DeKalb County Historic Preservation Commission

Monday, June 19, 2017 - 7:00 P.M.

Staff Comments

V. 1551 Briarcliff Road (DH), Residential Recovery Fund, LLC ("Minerva USA"). Divide the parent property into two parcels and develop one of those parcels, with the development including the construction of two multifamily buildings. 21354

EXHIBIT
B

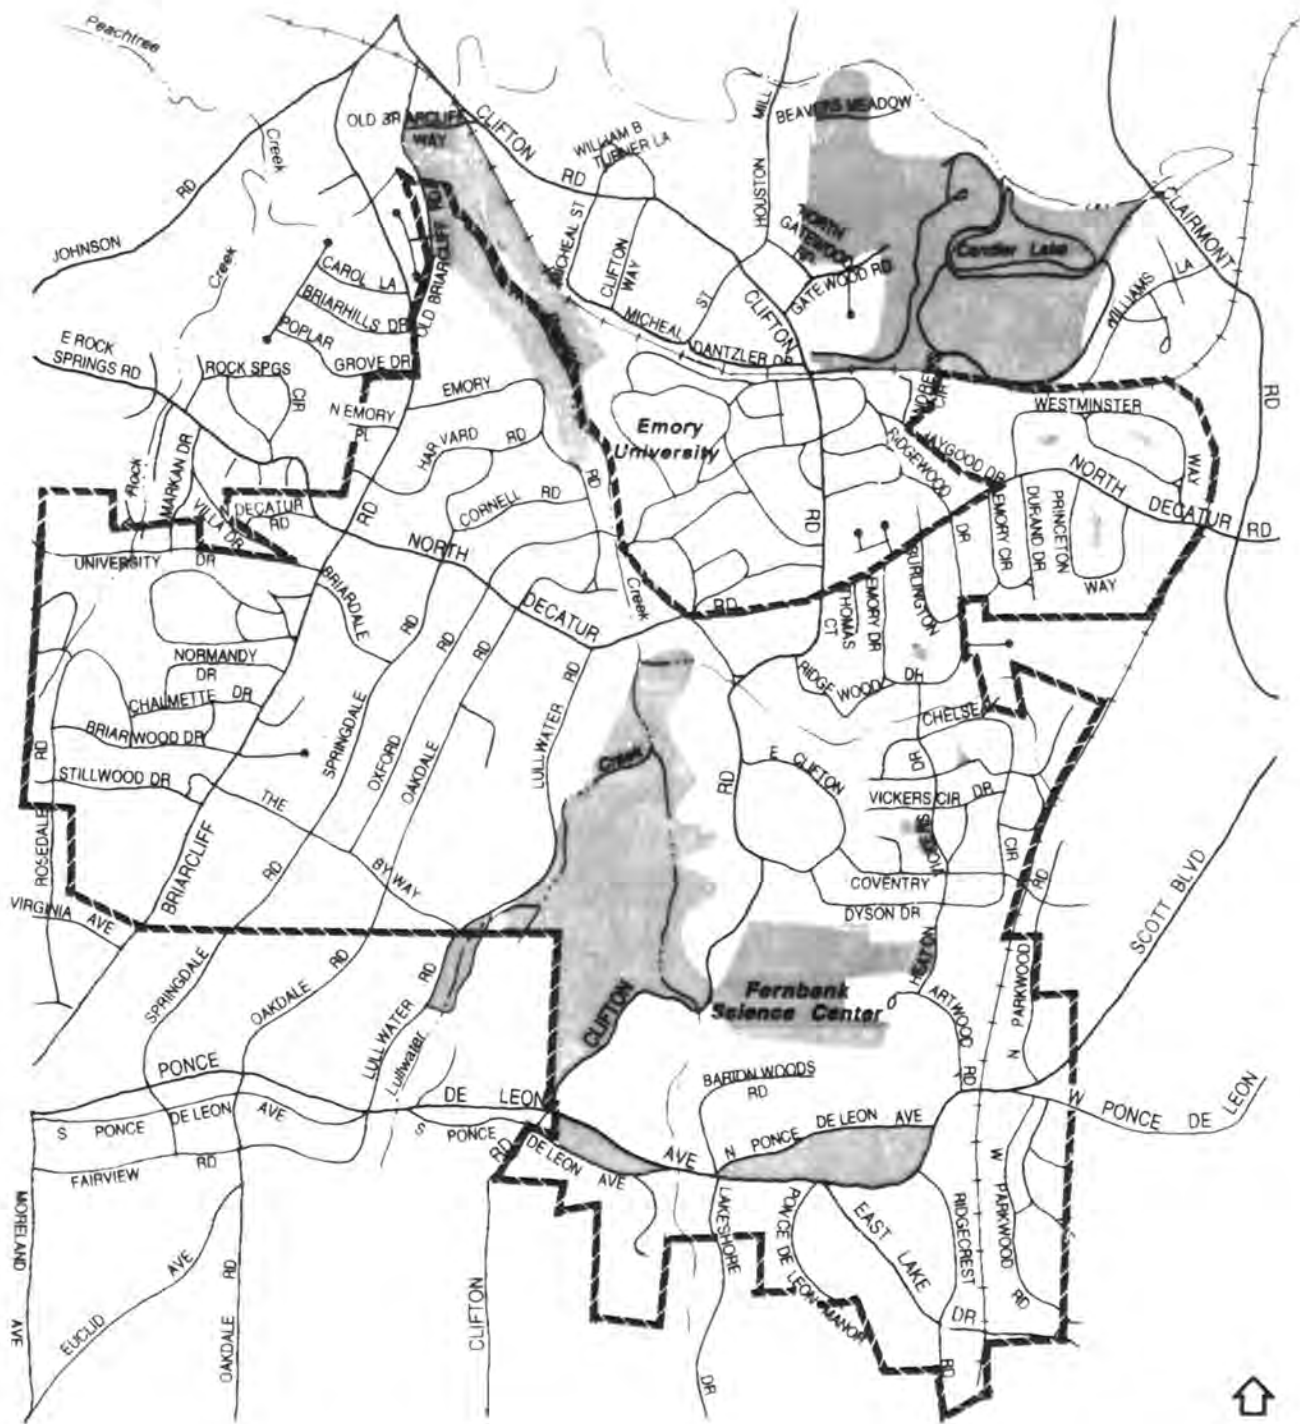
The official map of the Druid Hills Local Historic District is the map approved by the Board of Commissioners in their re-designation of the district in 2000. That map is included in this record as Druid Hills Local Historic District Exhibit B.

The official district map shows these properties shaded, however there are other shaded areas not included on this list. These other properties are the Lullwater Conservation Garden, Heaton Park, Princeton Park, the two components of Emory Grove Park, Ridgewood/Rutledge Park, Hummingbird Park, Emory’s Lullwater Preserve (outside the district) and the properties adjacent to Peavine Creek on the west side, beginning in the vicinity of 1498 Emory Road on the south and running north beyond the boundary of the historic district.

The area west of Peavine Creek includes part of 1551 Briarcliff Road, but the boundary of the area is imprecise. Part or all the subject 2.2 acre area does not appear to be included.

Guideline 8.3 says that construction should be set back 75’ from the top of bank of creek corridors and drainage ways as delineated on the official “Historic District Map”. Although the map shows Peavine Creek, it does not show the small stream that flows along the edge of the subject property. The only streams shown in the historic district are Peavine Creek, the south fork of Peavine Creek and Lullwater Creek.
